# Fort Mason Center for Arts & Culture Entranceway Public Art Project

Final Design

**Version 5.0 – Design with SFAC Recommendations  
December 13, 2016**

*Tide/Untied*

## Site Plan

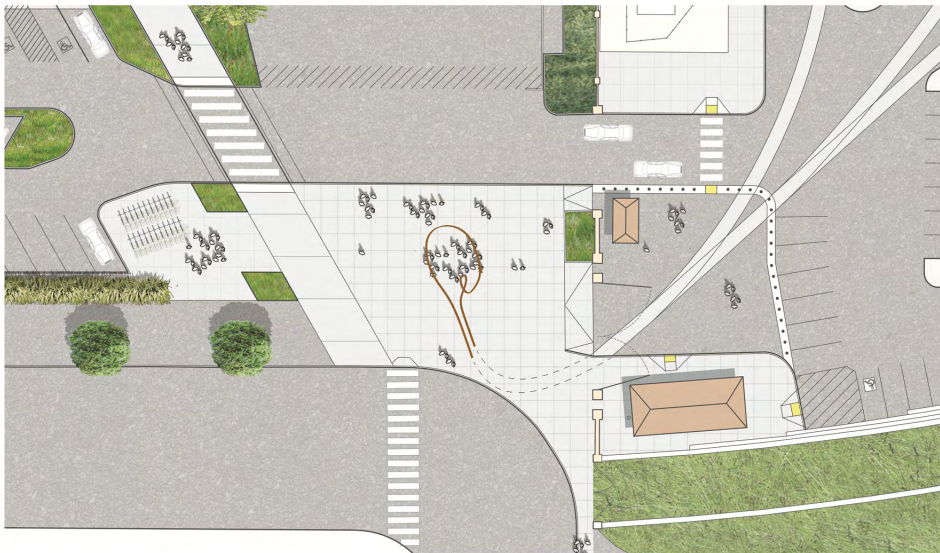
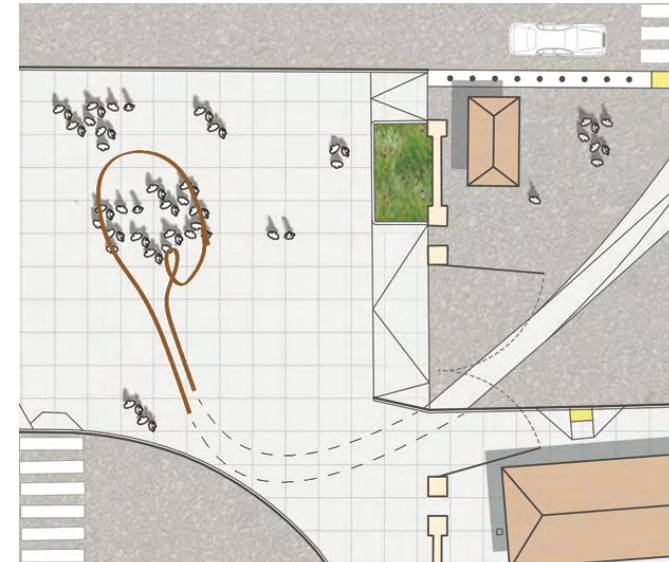
Staff noticed that several sections of the sculpture might create a tripping hazard without proper indication of a change in materials, or a curb around the piece. The most elegant solution to us is to use a different ground material than the rest of the plaza. This different material could be a different paver, gravel, or another treatment sufficient to be noticed by visitors using canes.

Susan and Jill also indicated concern regarding the rust patina on the surface of the sculpture. This issue has two components: staining from water runoff sheeting off the piece that will color the ground beneath the sculpture, and the long-term durability of the metal. The first issue will be addressed through the use of different ground cover, as described above.

We are currently in conversation with the project landscape architect (CMG) and ADA experts to select the proper ground cover that will create a safe, useful and elegant solution to this issue.
